KNOX COUNTY HISTORIC ZONING COMMISSION STAFF REPORT - CERTIFICATE OF APPROPRIATENESS APPLICATION

FILE NO.: 1-H-20-HZ

PROPERTY LOCATION: 1321 Harvey Rd. /
Parcel ID 162 02944

DISTRICT: Boyd-Harvey House Individual HZ Landmark

West elevation after work; pergola added to enclosed porch section, replacement door, one window added

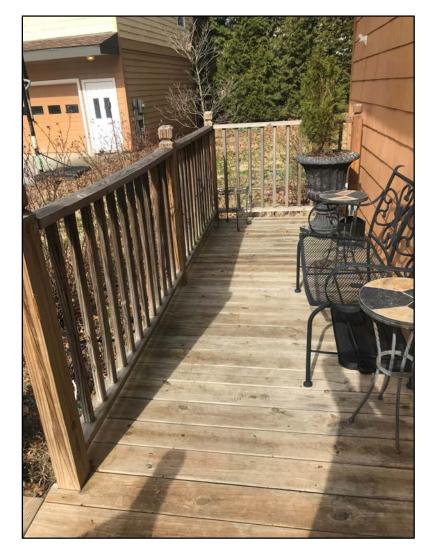
- 1. The wood-frame pergola is located on a non-character-defining elevation of the house and not visible from the public right-of-way on Harvey Road. It connects only to the section of the rear porch enclosed in the 1990s, does not alter any historic masonry, and could be easily removed with no effect on the historic house. The wood materials are appropriate for a pergola structure and compliment the one-story, shed-roof porch on the rear.

- 2. The doors replaced on the main house are not visible from the public right of way, and are located on the non-historic, enclosed shed-roof porch section. The wood, full-light doors are appropriate for the historic house.

View of new window, deck, and replacement door

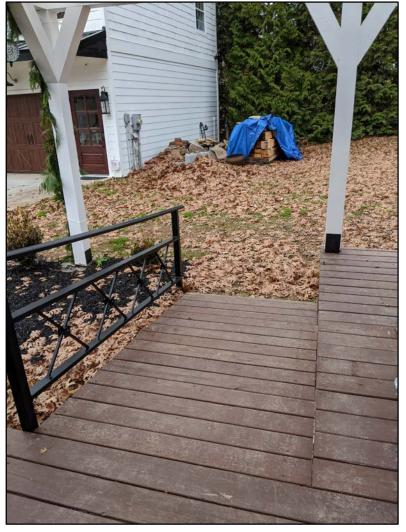
- 3. The installation of two adjoining, nine-light, wood-clad windows on the west elevation creates a new fenestration in the c.1990 enclosed porch only, and the materials and design of the windows are appropriate for the historic context.
